USA HEALTH SYSTEMS SUBDIVISION

APPLICATION NUMBER 6 DATE May 15	5, 2008 N
APPLICANT USA Health Systems Subdivision	<u>n</u> }
REQUESTSubdivision	
	NTS

Revised for the May 15th Meeting:

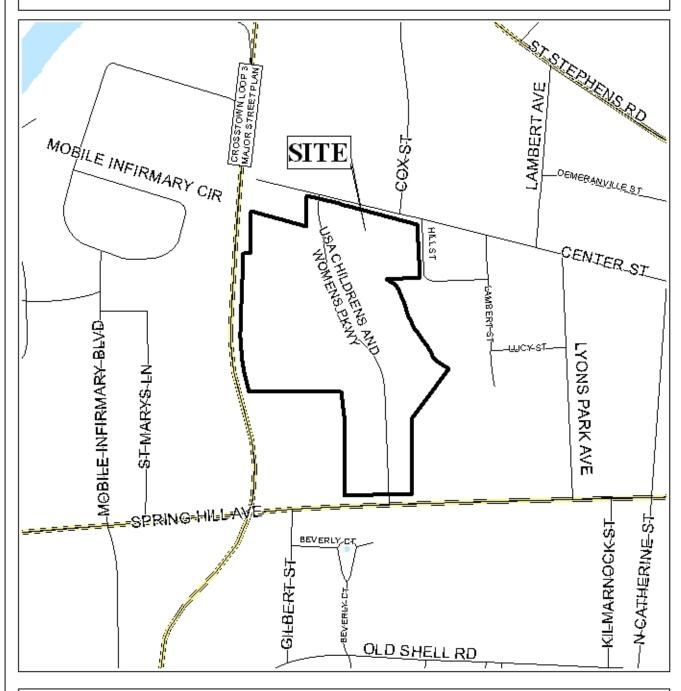
The application was heldover from the April 17th meeting to allow the applicant to revise the plat to include the parcel located to the South and West of Center Street and to submit new labels and postage for re-notification. The applicant submitted a revised plat showing no change to lots 2 and 3 and a decrease in acreage in lot 1 from 27.57 acres to 7.67 acres. Lot 1 no longer includes the property North of Center Street. In addition, the applicant stated that though the property to the South and West of Center Street is shown as University of South Alabama owned property, it is in fact owned by Infirmary Health Systems. The applicant submitted a letter stating that Infirmary Health Systems does not wish to participate in the subdivision application. Furthermore, it appears the property is part of an existing Planned Unit Development for Mobile Infirmary. It should also be noted that re-notification was not required due to there being no additional property added.

Based on the preceding, the application is recommended for Tentative Approval subject to the following conditions:

- 1) placement of a note on the plat stating Lot 1 is limited to curb cuts to USA Children's and Women's Parkway and its existing curb cuts to Center Street;
- 2) Lot 2 is limited to curb cuts to USA Children's and Women's Parkway and Mobile Infirmary Drive;

- 3) Lot 3 is limited to the existing curb cut onto Springhill Avenue;
- 4) all curb cuts' size, location and design to be approved by Traffic Engineering and conform to AASHTO standards;
- 5) labeling of each lot with its size in square feet on the final plat; and
- 6) placement of a note on the plat stating that the site must be developed in compliance with all local, state and Federal regulations regarding endangered, threatened or otherwise protected species.

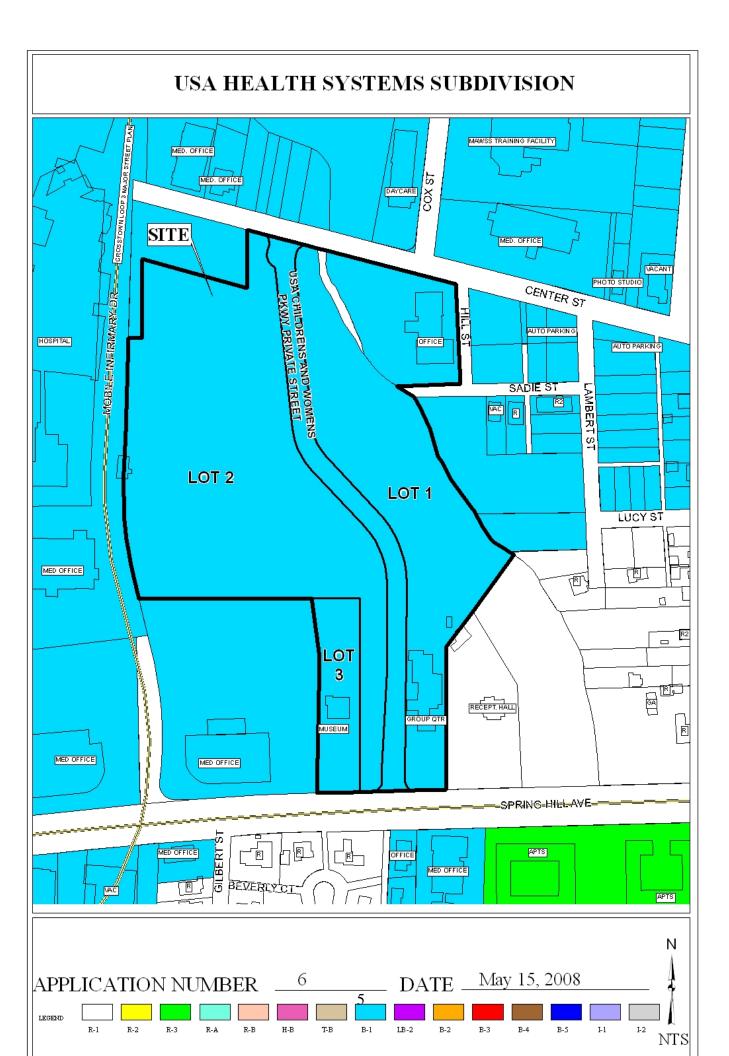
Proposed Lots 1, 2 and 3 are substantially large in size therefore access management is a concern. As a means of access management, a note should be placed on the final plat, if approved, stating that Lot 1 is limited to curb cuts to USA Children's and Women's Parkway, the to be vacated Center Street, and its existing curb cuts onto Cox Street. Lot 2 should also be limited to curb cuts to USA Children's and Women's Parkway and Mobile Infirmary Drive, also a private street and Lot 3 is limited to the existing curb cut onto Springhill Avenue. All curb cuts' size, location and designs are to be approved by Traffic Engineering and conform to AASHTO standards.

The lot sizes in square feet, at a minimum, should also be depicted on the final plat, or a table provided furnishing the same information, if approved.

Section V.D.2 of the Subdivision Regulations state that the maximum depth of any lots, exclusive of unusable land, shall not be more than 3.5 times the width of the lot at the building setback line. However, due to the intended purpose of the application and the applicant being a state-owned entity, this regulation should be waived.

It should be noted that approval of the subdivision as proposed would leave a parcel located on the South and West sides of Center Street land locked. This parcel is owned by The University of South Alabama and as such, it should be included in the subdivision process.

Based on the preceding, this application is recommended for a holdover until the May 15th meeting, with revisions due by May 2, to allow the applicant to address the following:

- 1) revised plat to include the parcel located to the South and West of Center Street; and
- 2) submittal of new labels and postage required to re-advertise.
